DOCKET NO. 40-9027
LICENSE NO. SMC-1562
LICENSEE: CABOT PERFORMANCE MATERIALS, REVERE, PA
SUBJECT: SAFETY EVALUATION REPORT, SITE
DECOMMISSIONING PLAN, AND RADIOLOGICAL
ASSESSMENT, DATED MAY 24, 2001

Figure 1. Generalized conceptual model used in the Cabot-Revere assessment.

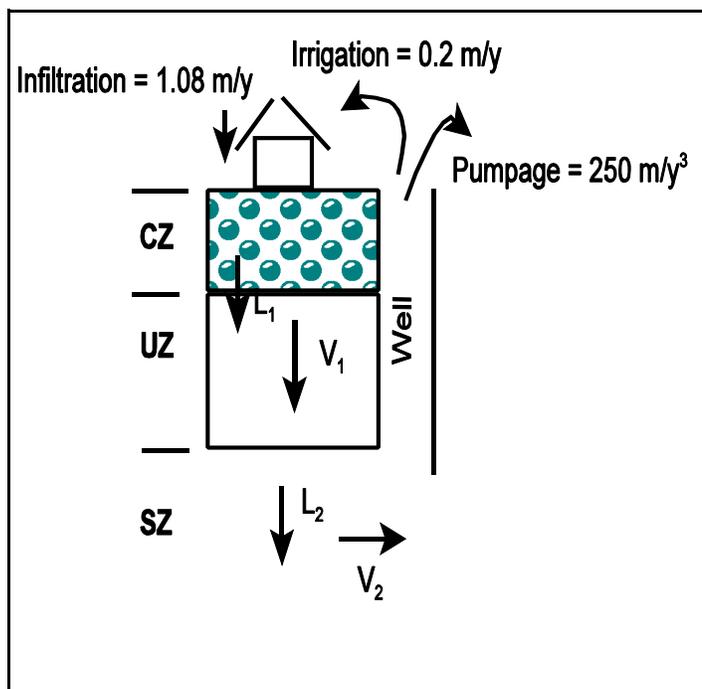
It should be noted that a default irrigation rate of 0.2 m/yr (0.7 ft/yr) was used in the analysis, although the licensee only assumed irrigation as part of its residential gardener scenario.

Based on regional information, the unsaturated zone is believed to be roughly 20 m (66 ft) thick; however, for the assessment, nominal credit is taken for the possible hold-up of contaminants migrating through the unsaturated zone. This is reflected by the small unsaturated zone thickness [0.01 m (0.03 ft)] assumed for the analysis. Staff believes that this adds conservatism to the calculated doses for the water-dependent pathways.
